## URBAN DESIGN COMMISSION APPLICATION CITY OF MADISON

United Brick & Fireplace

2702 Todd Drive

Amendment to an Approved Comprehensive Design Review

# (1.1) Main Identification Sign

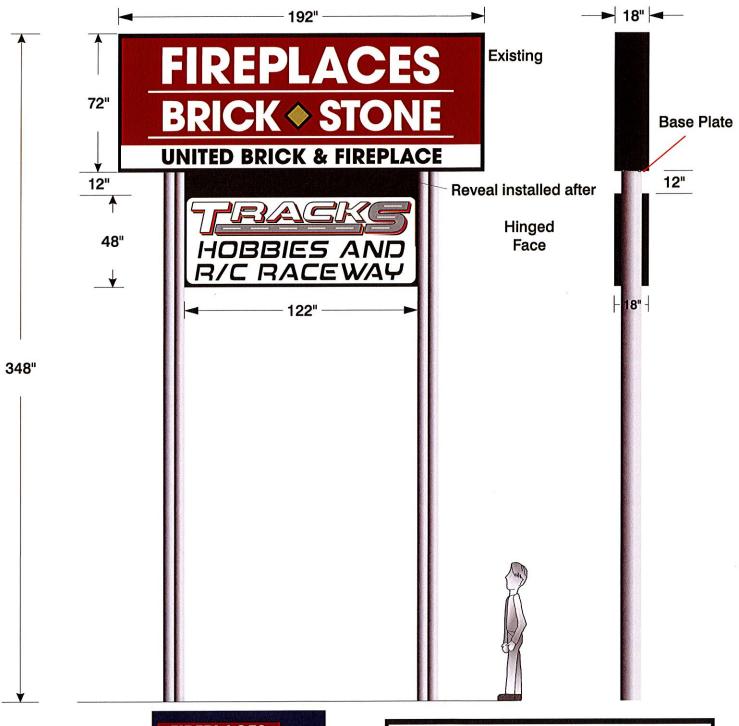
- 1. To allow for a new 4'-0" x 16'-0" (64 sf2) or 4'-0" x 10'-2" (41 sf2) double sided sign to be added to the existing pylon sign. Each of these buildings would be allowed freestanding signage up to 144 sf2 and 22'-0" overall height. The owner is proposing to self-limit the property to a single pylon sign and a single directional entrance sign.
  - a. By allowing the new 64 sf2 sign, the allowable square footage is exceeded by only 16 sf2.
  - b. If the tenant selects the new 41 sf2 sign, the size of the pylon sign is code compliant (137 total sf2).
- 2. To allow for the steel pipe structure to remain black (as is), or painted a neutral color to match a color of the building, with no masonry additions.
- 3. To allow for a new 3'-0" x 5'-0" double sided sign to be located at the north driveway of the zoning lot.
